Public Information Centre #2

Summary Report

Ojibway Parkway Wildlife Crossing
Municipal Class Environmental Assessment (Phase 1 to 4)
Windsor, Ontario

September 2021

Preliminary Preferred Design Concept

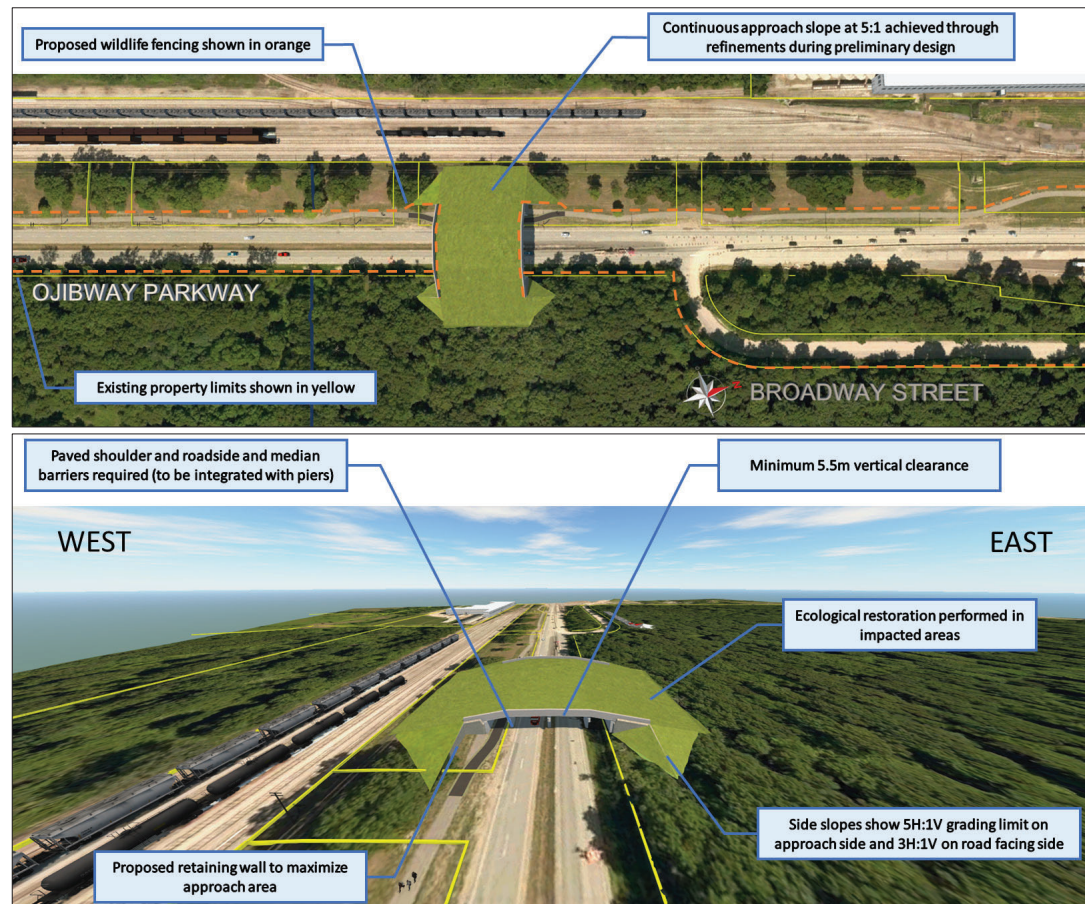
Suggestions for design considerations	<p>Following is a summary of comments sharing suggestions for design considerations:</p> <ul style="list-style-type: none"> • Consider creating optional paths for deer using appropriately sized aggregate. This would provide some traction for deer and they might prefer to use it. This may help minimize impacts on the rest of the soil and native vegetation and prevent creation of rutted paths or mud due to deer movement activity. • With a lot of potential wildlife crossings daily, a wide overpass, with trees and much cover, would be the preference. • Keep this crossing free of human use trails. Signage, possibly with a fine, could be used. As well the trail cameras set up for wildlife observation would themselves need to be surveilled in this area. The notices of photo surveillance may also keep humans away from this wildlife overpass. • If any proposed Wildlife Crossing is not designed to a higher level of endurance quality than a typical vehicular road bridge, then, potential reoccurring maintenance could only serve to destroy any planned vegetation growth or new established habitat on the Wildlife Overpass in the future. • Respect the existing wildlife movement corridors. The fencing for this overpass should not be so restrictive that the existing corridors can't be used. The existing wildlife corridors have known to exist at the following locations: <ul style="list-style-type: none"> ○ Either ends of the ETR railyard, where the track is narrower. ○ Corresponding ends of Ojibway Park, there are areas with no ditches or little fencing to cross. ○ There is a well-used deer trail along the fencing just outside Ojibway Parkway on Broadway Street, leading to the Broadway Loop (roadway). ○ Wildlife also filters up through the Hydro Corridor. There are also openings in 	<p>Comments noted. Once the environmental assessment is complete, the project will proceed to the detailed design phase. At that time, various detailed design consideration will be determined, including but not limited to the following:</p> <ul style="list-style-type: none"> • Materials (including soil and vegetation types) for the Wildlife Overpass • Design elements or other measures to deter human use of the Wildlife Overpass. These elements may include signage, surveillance equipment and monitoring. • Ultimate configuration and material for the fence.

<p>Suggestion for other alternative options for the crossing</p>	<p>Following is a summary of comments sharing other suggested alternative options for the crossing:</p> <ul style="list-style-type: none"> • An amended narrow overpass extension of the crossing over railway tracks with a small stone-substrate-rock treatment, as well as two vegetative strips as an added option. The concentration of wildlife here is unlike authentic wilderness overpasses in the frequency of anticipated use. • A small culvert or 2 could make this easier as well. • In the absence of an overpass spanning the rail yard, an underpass or other railroad crossing structure should be included as an additional component of this project. For example, there are two drains that cross under the rail yard to the north and south of the proposed crossing (Titcombe Rd. Drain, and Susan Drain). Can these provide safe passage for SAR turtles, either in their current state or if upgraded? A tool for the assessment of road-stream crossing for wildlife passage can be found here: https://streamcontinuity.org/naacc/assessments/terrestrialconnectivity. • Feasibility of installing simple railroad crossing structures under the rail lines should be investigated (e.g., targeted removal of ballast between existing or specialized rail ties: see Pelletier et al. 2005). To achieve the provisioning of “safe” passage for SAR snakes and turtles, the project needs to directly incorporate the best available knowledge gained from connectivity modelling and railroad ecology studies. • No alternative was considered for a road viaduct with a wildlife crossing land bridge at ground height (similar to the existing Herb Gray Parkway wildlife crossing or to have a wider Ojibway Wildlife Crossing that allows for a human path as well). 	<p>Thank you for your feedback. As presented at Public Information Centre #1, a Wildlife Overpass was identified as the preferred solution as part of the Phase 2 of the Municipal Class Environmental Assessment process for this project. Accordingly, various technically feasible alternative design concepts were identified and evaluated to identify a preferred design for the Wildlife Overpass.</p>
